BCA ASSESSMENT REPORT

2 Bardwell Crescent, EARLWOOD NSW 2206

Reference: 25220

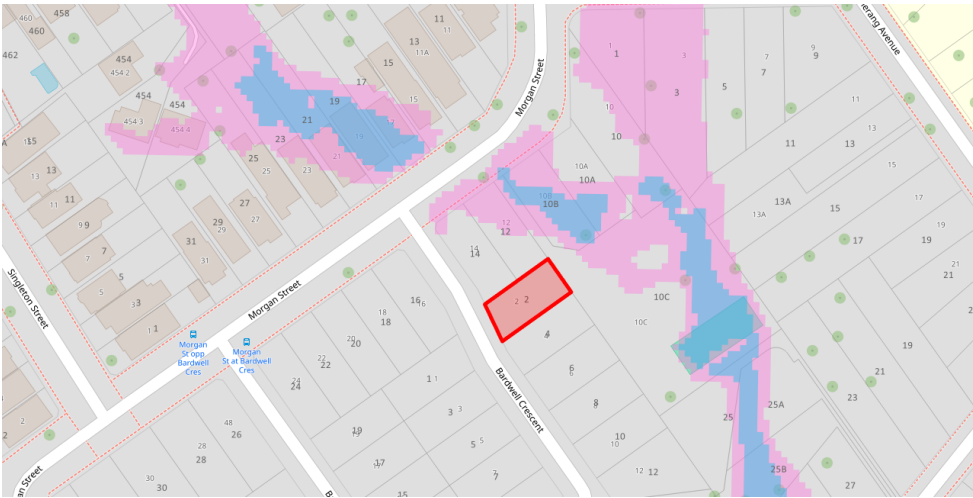
ABCBHP 3.4.1 [3.1.4.2]	Requirement for termite management systems	The existing dwelling is located in an area where subterranean termites are known to present a potential risk of attack and the primary building elements subject to this application are constructed of timber that is susceptible to termite attack.	Works Required/ Information Required

It is recommended that a certificate of installation be provided by the qualified pest controller who installed the chemical termite management system that confirms compliance with AS 3660.1-2014 (Amendment 1) and a durable notice be installed in the electrical box to comply with 3.4.3 of the ABCB Housing Provisions.	
ABCBHP 3.4.2 [3.1.4.3]	Termite management systems	Refer to the comments in ABCBHP 3.4.1 of this report.	Noted
ABCBHP 3.4.3 [3.1.4.4]	Durable notice	Refer to the comments in ABCBHP 3.4.1 of this report.	Noted
NSW H1D4 [3.2.0, 3.2.1]	Footings and slabs	<p><u>Dwelling</u> The building works to the rear of the dwelling are constructed on new timber stumps with footings.</p> <p>It is recommended a certificate of structural adequacy prepared by a professional engineer be obtained to confirm the footings are structurally adequate and comply with NSW H1D4 of the BCA.</p> <p><u>Garage</u> The garage is constructed on an existing concrete slab that has not been altered as part of the works subject to this application. The garage is a detached Class 10a building that is not required to be provided with a vapour membrane underneath the slab in accordance with NSW 4.2.8 of the ABCB Housing Provisions.</p>	<p>Information Required</p> <p>Noted</p>

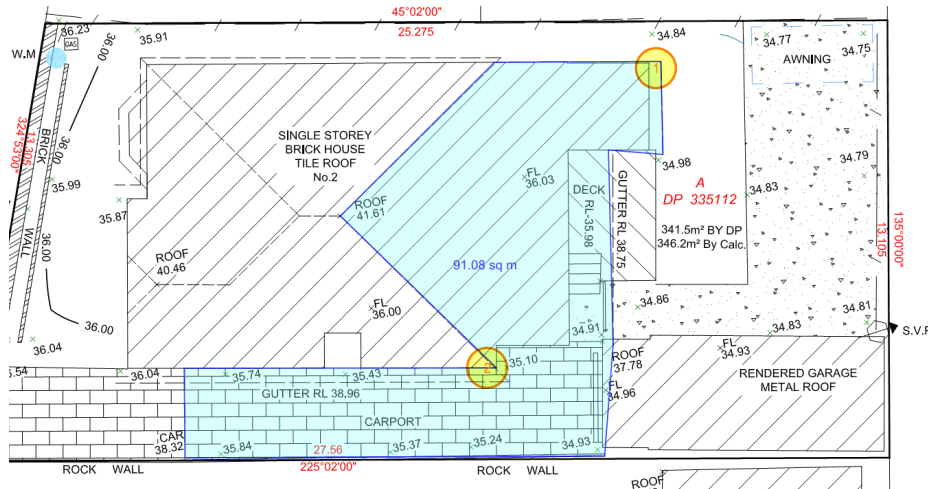
<p>H1D6 [3.4.0, 3.4.2- 3.4.4]</p>	<p>Framing</p>	<p><u>Steel framing</u> The building works subject to this application does not include a steel frame.</p> <p><u>Timber framing</u> The building works to the rear of the dwelling to create kitchen, dining, living, bathroom, laundry and deck include the construction of a timber frame for the stumps, floor, walls and roof frame.</p> <p>It is recommended a certificate of structural adequacy prepared by a professional engineer be obtained to confirm the residential timber-framed construction complies with AS 1684.2-2021 and/ or AS 1684.4-2010 (Amendment 1) and is structurally adequate.</p> <p><u>Structural steel members</u> The building works subject to this application does not include structural steel members.</p>	<p>Not Relevant</p> <p>Information Required</p> <p>Not Relevant</p>
<p>H1D7 [3.5, 3.5.1- 3.5.5]</p>	<p>Roof and wall cladding</p>	<p><u>Sheet roof cladding</u> The alterations and additions to the rear of the dwelling include the construction of a new roof with sheet roof cladding.</p> 	<p>Information Required</p>

<p>The roof has a pitch of approximately 8 degrees, which complies with the minimum pitch in accordance with Table 3.1 of AS 1562.1-2018.</p> <p>It is recommended a certificate of installation prepared by the builder who installed the roofing be provided to confirm the sheet roof cladding has been installed to comply with AS 1562.1-2018 and H1D7 of the BCA.</p> <p><u>Tiled roof cladding</u> The existing dwelling contains tiled roof cladding. The existing tiled roof cladding does not form part of this application.</p> <p><u>Timber and composite wall cladding</u> Compliance with Part 7.5 of the ABCB Housing Provisions satisfies Performance Requirement H1P1 for timber and composite wall cladding. Refer to the comments in ABCBHP 7.5.1 – 7.5.8 of this report.</p> <p><u>Metal wall cladding</u> The building works subject to this application does not include any metal wall cladding.</p>	<p>Not Relevant</p> <p>Noted</p> <p>Not Relevant</p>

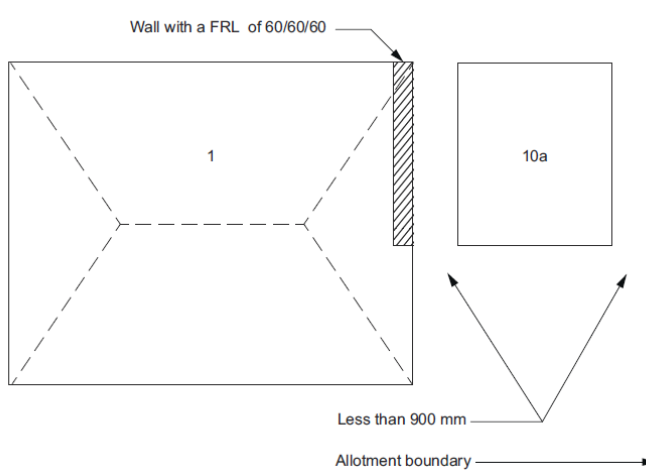
<p>ABCBHP 7.5.4 [3.5.4.4]</p>	<p>Sheet wall cladding</p>	<p>The alterations and additions to the rear of the dwelling and part of the garage (located above the glass sliding door) is constructed with fibre-cement sheeting that appears to be comply with 7.5.4(1) of the ABCB Housing Provisions based on a visual inspection.</p>	<p>Complies</p>
<p>ABCBHP 7.5.5 [3.5.4.5]</p>	<p>Eaves and soffit linings</p>	<p>The rear and side eaves of the works to the rear of the dwelling have been lined with fibre-cement sheets. A visual inspection of the eave linings indicates the rear eaves comply with 7.5.5 of the ABCB Housing Provisions, however, the side eave lining contains unfinished gaps.</p>  <p>It is recommended the side eave lining be finished with weather sealing/ moulding in accordance with 7.5.5 of ABCB Housing Provisions.</p>	<p>Work Required</p>
